Reference:  
New Beam at Opening in Existing Bearing Wall  
127 York Street  
Portland, Maine 04101

Structural Integrity Job: #10-0142

As requested I am writing this memo regarding the installation of a new beam at a small opening in a main level bearing wall at 127 York Street.

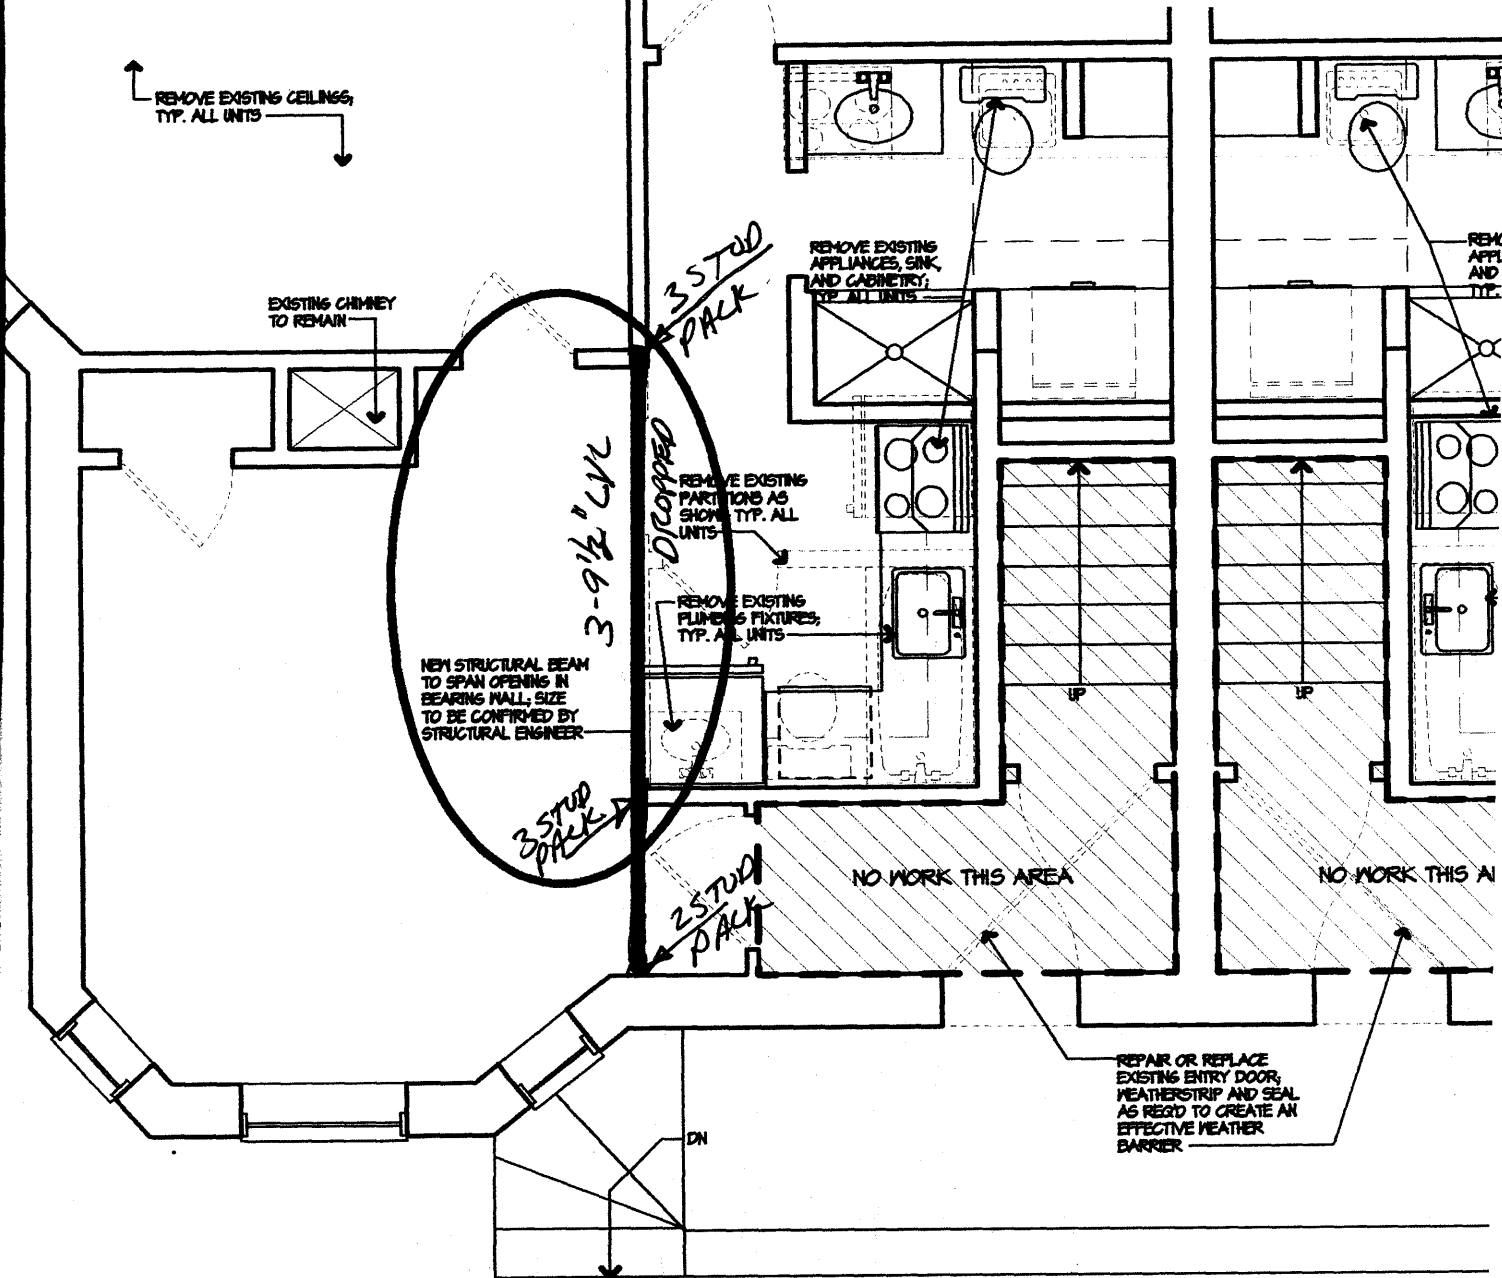
Please add a triple 9 1/2" deep LVL dropped beam as shown in the attached sketch. The new dropped beam should stack over three new stud pack posts which will stack over the existing main level girder, columns and foundation.
